FINAL PLAT

BRADFORD NORTH 3RD ADDITION

Re: S/D 97-25 - BRADFORD 3RD ADDITION (Final Plat)

CASE NUMBER: S/D 97-25 - BRADFORD NORTH 3RD ADDITION

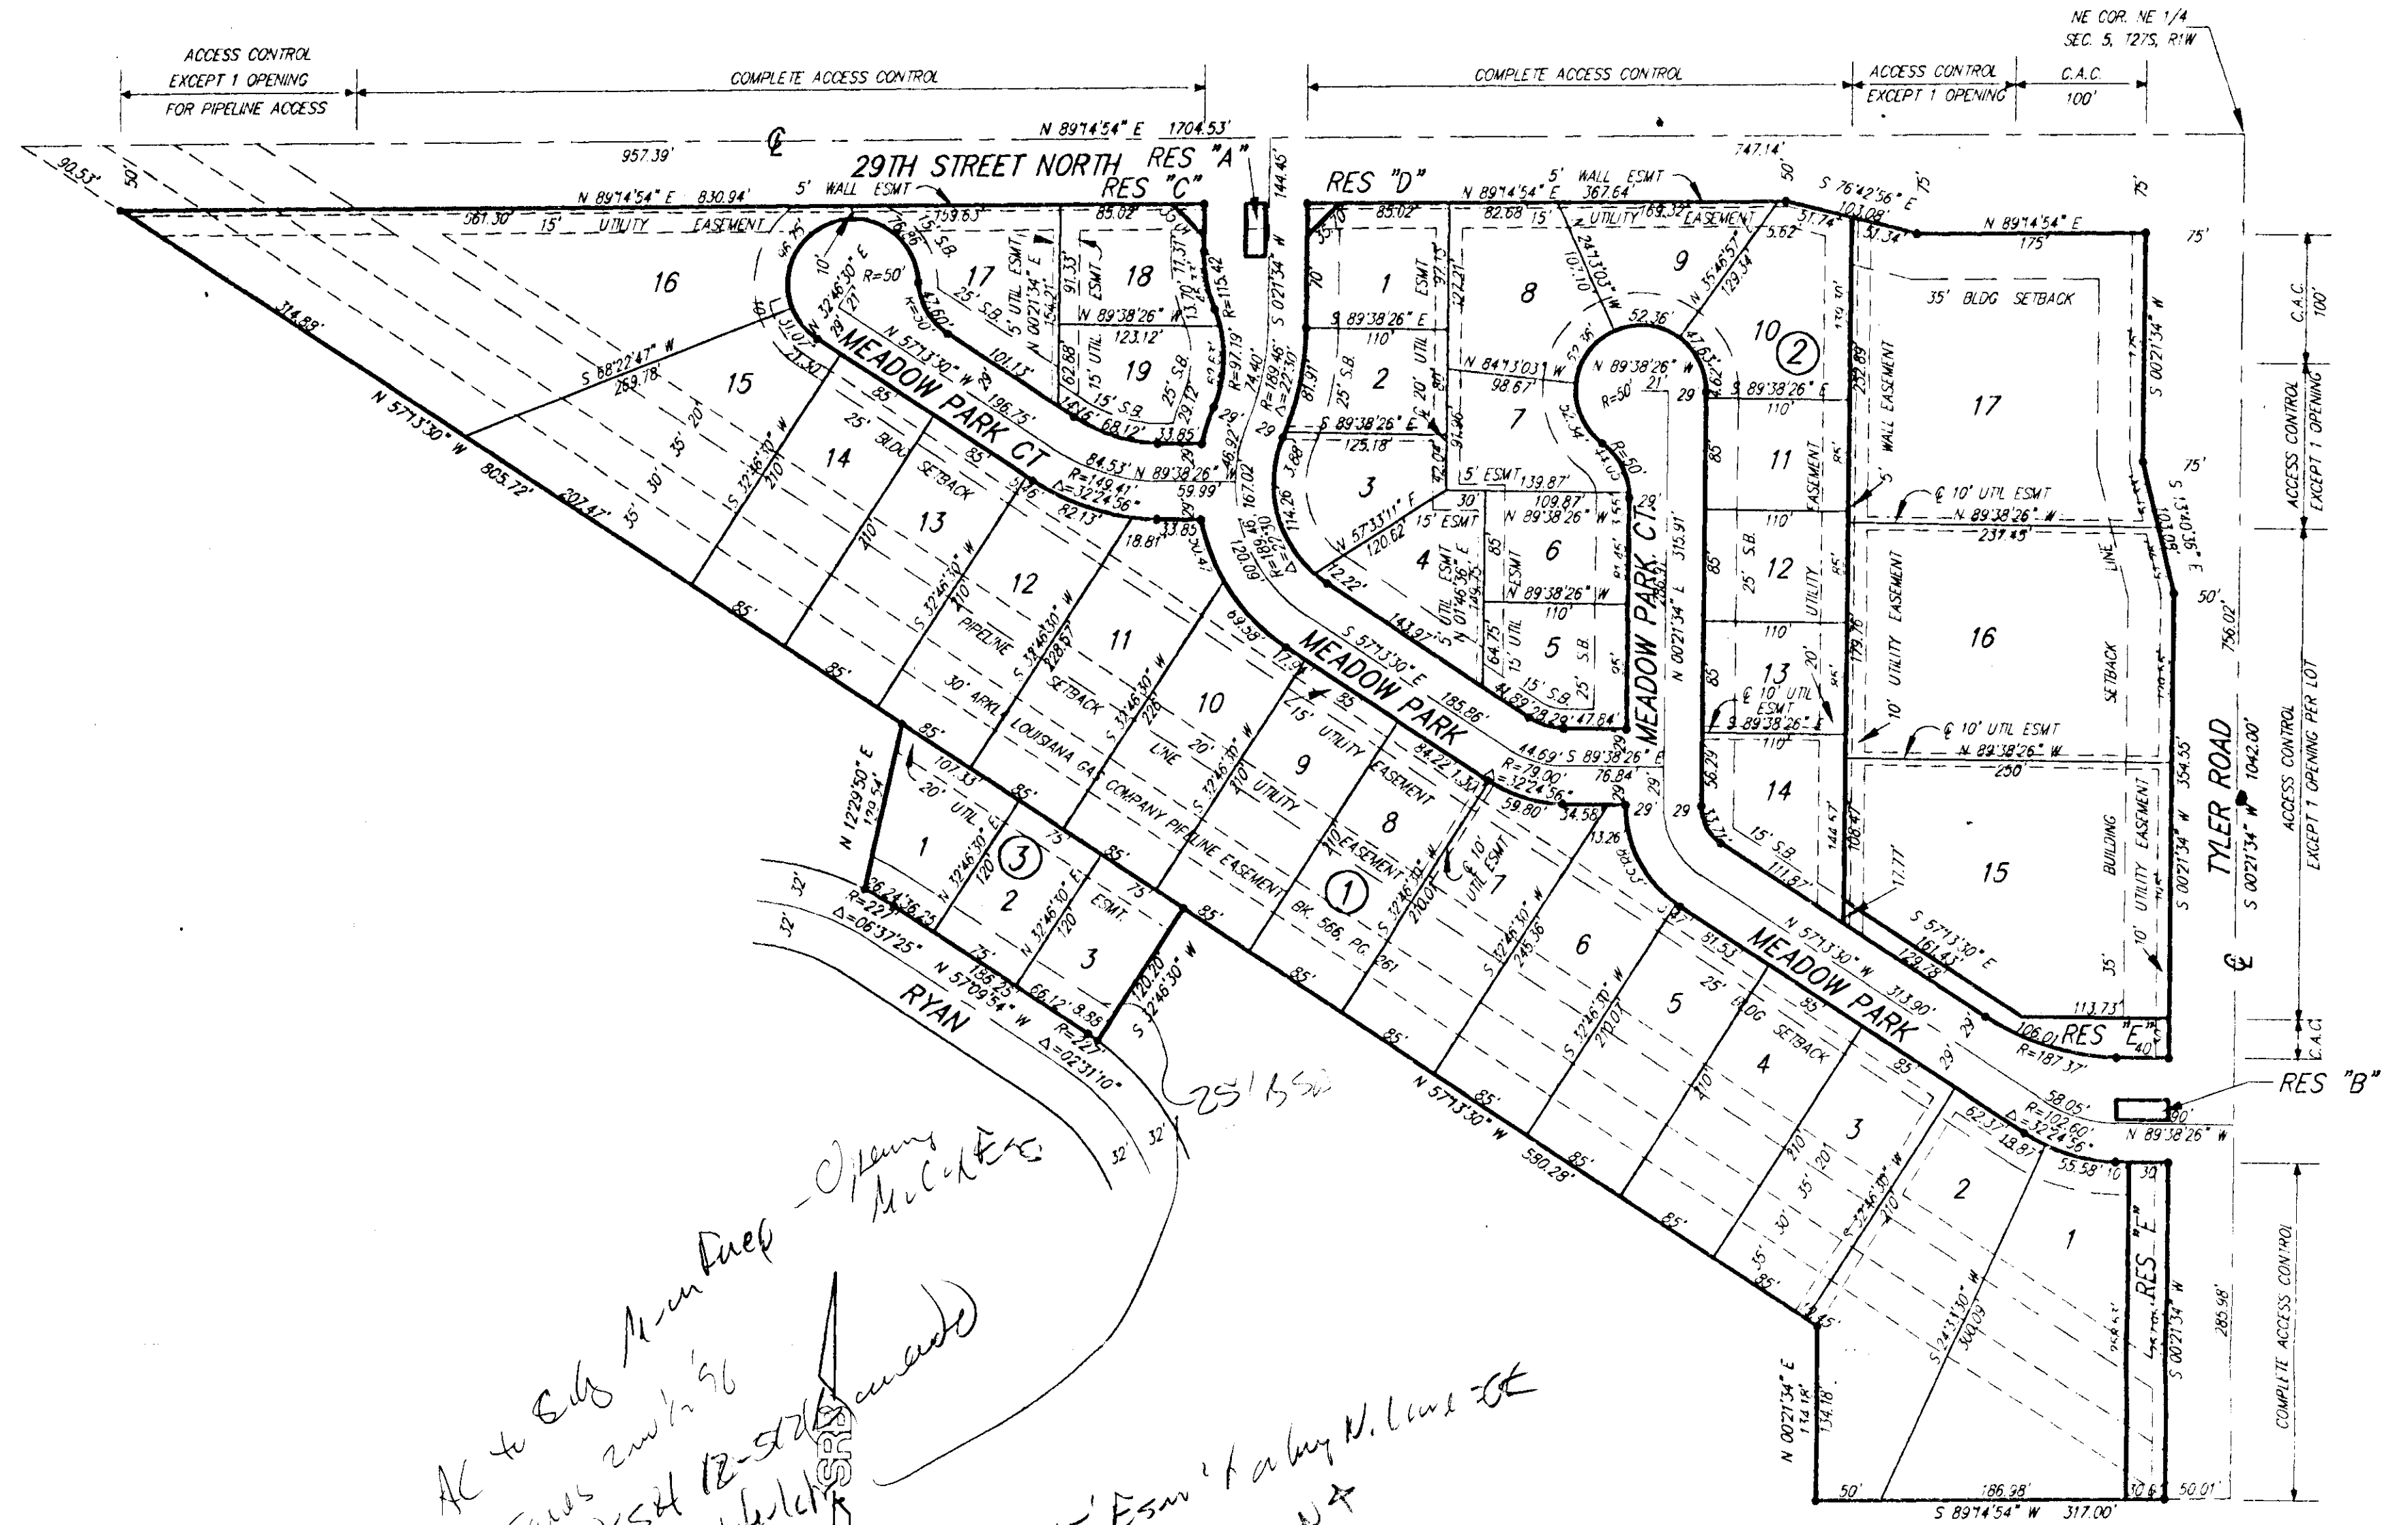
AC to City of Wichita - Openings
Taxes 2/15/96
Side R/S of 12-5th St
25' KSA wall building
? City Enc. - 15' Esm't of a long N. line - SE
S.B. = 50' Set RE higher than WA
Iron Set

- B. ✓ The applicant shall guarantee the extension of sanitary sewer to serve the lots being platted. As requested by City Engineering, a sewer layout plan shall also be provided to City Engineering. If sewer is planned along the north line of this plat, City Engineering indicates the need for a 20-foot easement.

- I. ✓ Provisions shall be made for ownership and maintenance of the proposed reserves. The applicant shall either form a lot owners' association prior to recording the plat or shall submit a covenant stating when the association will be formed, when the reserves will be deeded to the association and who is to own and maintain the reserves prior to the association taking over those responsibilities. This covenant shall also provide for the home/lot owners association to maintain the "parking strip" areas located between the perimeter of this plat and the driving surfaces of both 29th Street North and Tyler Road.

- J. ✓ The applicant's agent shall determine any setback requirements from the pipeline by researching the text of the pipeline agreement. If a setback from the pipeline easement is provided for in the pipeline easement agreement, it shall be indicated on the face of the plat.

- K. ✓ Any relocation, lowering or encasement of the pipeline, made necessary by this development, will not be at the expense of the City.
- L. ✓ On the final plat tracing, dimensions from lot corners shall be shown for lots 1 and 16 in Block 1 so as to better locate the easements along these lots' side property lines.

- M. ✓ On the final plat tracing, the platter's text shall be revised to properly reference the dedication of access control. Specifically, the present wording should be expanded to note that the access control is being granted to the City of Wichita (as indicate in the face of the plat), with the location of openings to be approved by the City Engineer.

- N. ✓ Since this plat is replatting or vacating and replatting various public reservations, the surveyor's text should reference KSA 12-512 (b) as amended.

- O. ✓ On the final plat tracing, the building setback on Lots 1, 2, and 3, Block 3 shall be labeled.
✓ Below the north arrow, the legend shall also note that S.B. is for the Building Setback. Also, if the "control point" stands for iron or rebar set, the legend should also note that for the dot symbol.

- W. ✓ The representative from City Engineering indicated that the applicant's drainage plan has been approved and guarantees are required.
- X. ✓ KG&E indicated the need for easements along Lots 15, 16 and 17.
